**NOTICE OF  
REGULAR MEETING OF THE PLANNING AND ZONING COMMISSION  
HICKORY CREEK TOWN HALL  
1075 RONALD REAGAN AVENUE, HICKORY CREEK, TEXAS 75065  
TUESDAY, AUGUST 16, 2022, 6:00 PM**

**PRELIMINARY PLAT**  
 FOR  
**RESERVE AT HICKORY CREEK**  
 BLOCK A, LOT 1-12, BLOCK B LOT 1-15, BLOCK C, LOT 1-12, BLOCK D LOT 1-15,  
 BLOCK E, LOT 1-12, BLOCK F, LOT 1-5, BLOCK G, LOT 1-20,  
 230 RESIDENTIAL LOTS/ 16 BLOCKS/ 17 OPEN SPACES  
 BEING 18.85ACRES  
 OF THE  
 HH Swisher Survey SURVEY, ABSTRACT NO. 1220  
 IN THE  
**TOWN OF HICKORY CREEK, DENTON COUNTY, TEXAS**

**SITE PLAN**  
 FOR  
**RESERVE AT HICKORY CREEK**  
 BLOCK A, LOT 1-20, BLOCK B LOT 1-15, BLOCK C, LOT 1-12, BLOCK D LOT 1-15,  
 BLOCK E, LOT 1-12, BLOCK F, LOT 1-15, BLOCK G, LOT 1-15, BLOCK H, LOT 1-20,  
 230 RESIDENTIAL LOTS, 16 BLOCKS, 17 OPEN SPACES  
 BEING 18.85ACRES

August 10, 2022  
AVO 37638.200

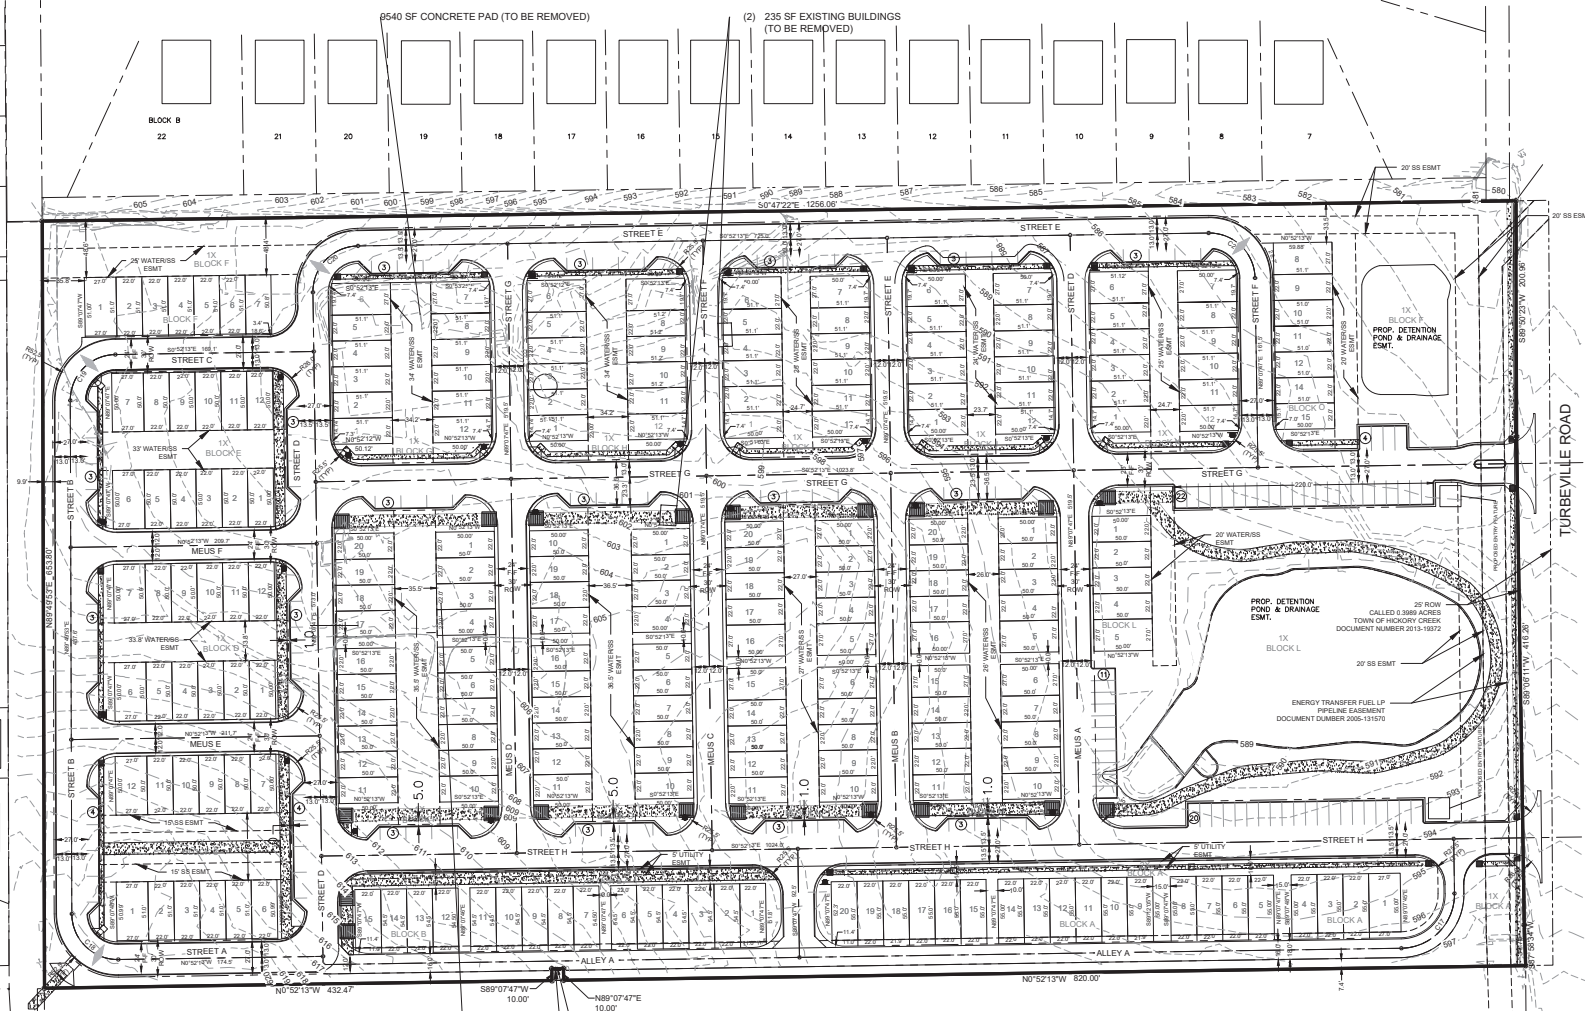
1. Please note the proposed detention ponds will require a Stormwater Facilities Maintenance Agreement (to also include the retaining walls). This will not be executed until acceptance of Construction Plans.  
*2<sup>nd</sup> Review: Applicant has acknowledged.*

3. Please show the limits of the 100-year floodplain and floodway as defined by FEMA.  
*2<sup>nd</sup> Review: No FEMA floodplain within or adjacent to property.*

4. A floodplain easement will be required to encompass the fully developed 100-year water surface elevation plus one foot of freeboard or 10 feet of horizontal distance, whichever is greater.  
*2<sup>nd</sup> Review: Applicant has acknowledged and will include in final plat and construction plans. The boundary of the floodplain easement will be determined as part of the ongoing drainage study.*

5. The planned detention ponds will require an emergency spillway encompassed by a drainage easement that directs overflow either to the stream or to ROW.  
*2<sup>nd</sup> Review: Applicant has acknowledged and will include in final plat and construction plans.*

6. The location and width of sidewalks are required. Sidewalks are required to connect each lot to a public sidewalk within ROW or easement. Sidewalk easements must cover the sidewalk plus 2 feet each side.  
*2<sup>nd</sup> Review: Applicant will include sidewalk easements in the final plat after the location of sidewalks is determined in the construction plans. A note was added to the preliminary plat to require sidewalks to each residential lot.*

7. Include gross acreage for all non-residential lots, acreage for residential use, acreage of streets, parks and other non-residential uses.  
**2<sup>nd</sup> Review: Not addressed. Sheet 1 has a note referring to a Lot Table on Sheet 2, which I assume contains this information. However, there is no Lot Table on the plat Sheet 2 submitted.**

16. Turbeville Road ROW is missing dimension and recording information.  
**2<sup>nd</sup> Review: Addressed.**
17. Please make dimensions of streets clearer. Check all dimensions for accuracy and consistency. Clearly show 27 feet to back-of-curb to back-of-curb and 13 feet to front-of-curb each side of the centerline.

**2<sup>nd</sup> Review: Not addressed. It looks as though they point to the same location and thus the two dimensions don’t add up to the overall dimension. Please move these to point to curb locations or otherwise make this clearer.**

19. Alleys require minimum 18-foot ROW. Show the ROW on each side and dimension.  
**2<sup>nd</sup> Review: Not addressed. ROW line not shown on west side of alley and 5-foot utility easement required by PD standards not shown.**

20. What is the plan for the alley at the 10-foot square leave out from the property on the west boundary? The plan currently shows the pavement edge going across the property line.

**2<sup>nd</sup> Review: Not addressed.**
21. Show a radius at the alley intersections.  
**2<sup>nd</sup> Review: Not addressed. Showing ROW with radius but pavement is not.**

22. Minimum guest parking required by PD is met (0.5 spaces per dwelling x 230 dwellings = 115 required. 116 provided). Check requirements for handicap accessible parking spaces and provide accordingly if required. Notwithstanding TDLR requirements, provide at least one van-accessible space in each of the parking space banks on either side of the detention pond on Street H and Street G.

**2<sup>nd</sup> Review: Not addressed.**
23. Correct the typical sections on Sheet 2:

- a. Labels show Section A-A, B-B, and C-C. These are not shown on the plan view. Change titles to reflect Street, Mews Alley, and Alley.
- b. Correct the proposed ROW and add dimensioning to clearly show lanes and ROW for the street typical section.
- c. Correct the alley pavement width to 16 feet.

24. Streets must be named in Preliminary Plat per Town Subdivision Ordinance.
25. Please identify the gray boxes in the legend or remove if inadvertent.
26. No Lot Table on Sheet 2 as noted in the second note.
27. Please update the date of preparation.

**PRELIMINARY LANDSCAPE PLAN**  
FOR  
**RESERVE AT HICKORY CREEK**

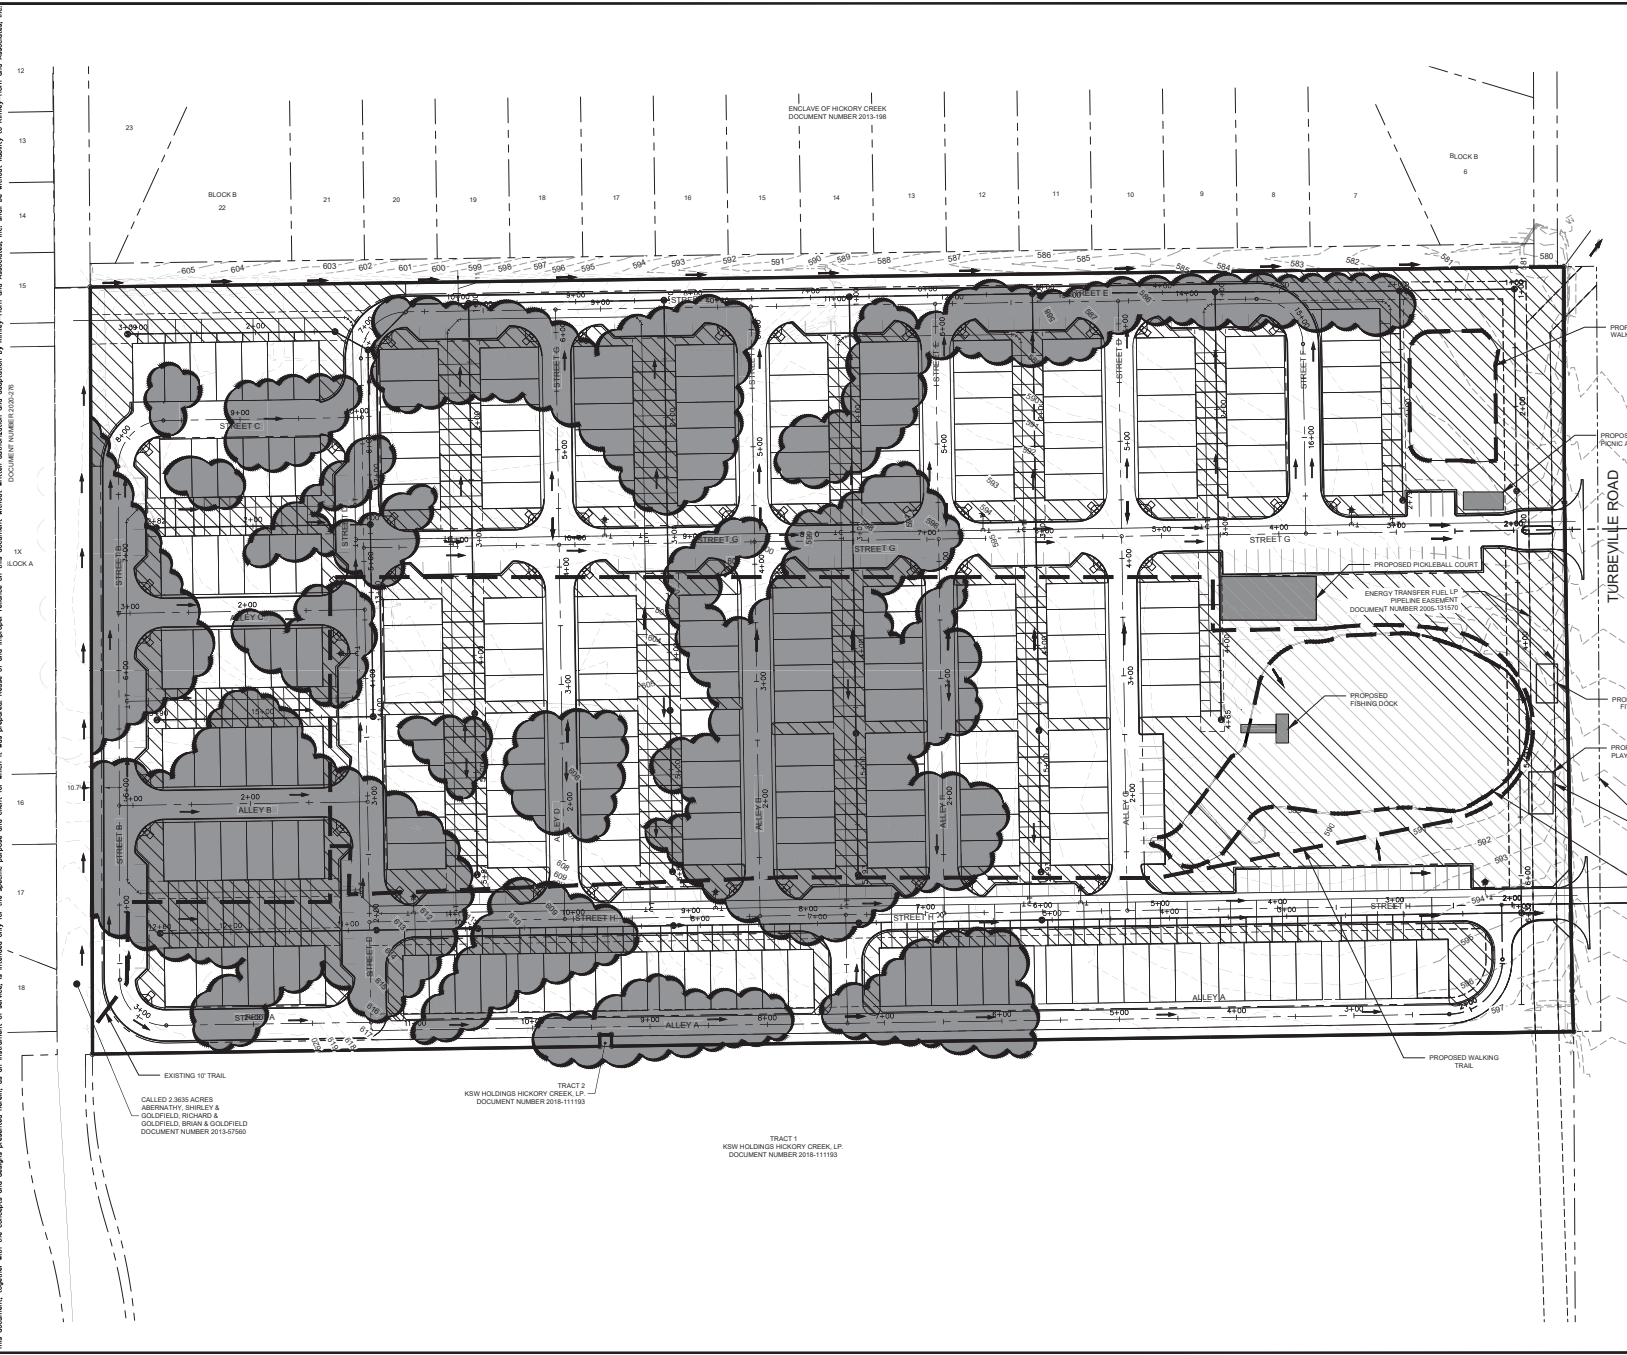
1. Show and label fences, screening walls, etc.  
2<sup>nd</sup> Review: Not addressed.
2. Show floodplain, drainage ways, and/or creeks, if any.
3. 2<sup>nd</sup> Review: Addressed.

4. Correct the scale.
5. 2<sup>nd</sup> Review: Addressed.
6. Tree survey including existing and preserved trees' location, size, and species not included with this submittal.  
2<sup>nd</sup> Review: Not addressed.

7. Proposed plant materials and landscaping materials not included with this submittal.  
2<sup>nd</sup> Review: Not addressed.
8. Please include a note to indicate the type and placement of irrigation system.  
2<sup>nd</sup> Review: Not addressed.

9. Show or note that for single-family lots, and prior to any occupancy of the dwelling, a minimum of one (1) tree with a minimum caliper of three (3) inches, measured at a point six (6) feet above ground level shall be required for all lots and shall be located within the front of the lot, or nearby common area. Trees may be ornamental or shade tree.  
2<sup>nd</sup> Review: Not addressed.
